Access Compliance Report Public Rights-of-Way (Curb Ramps)

Main Street: CRAWFORD_CANYON_RD Cross Street: CHAPMAN_AVE Location: SW

ADA ID: RPRK211007170911 Ramp Type: Type 1 - Perpendicular Diagonal Initial Pass/Fail: Fail Overall Compliance: No Severity Score: 30

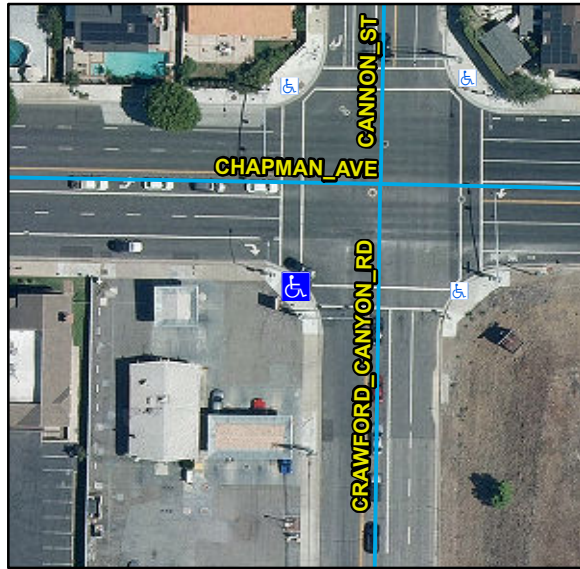
Possible Solutions:

Remove & Replace Curb Ramp With Two New Directional Ramps or Equivalent.

R304.2.2, R304.5.3, STD 1115
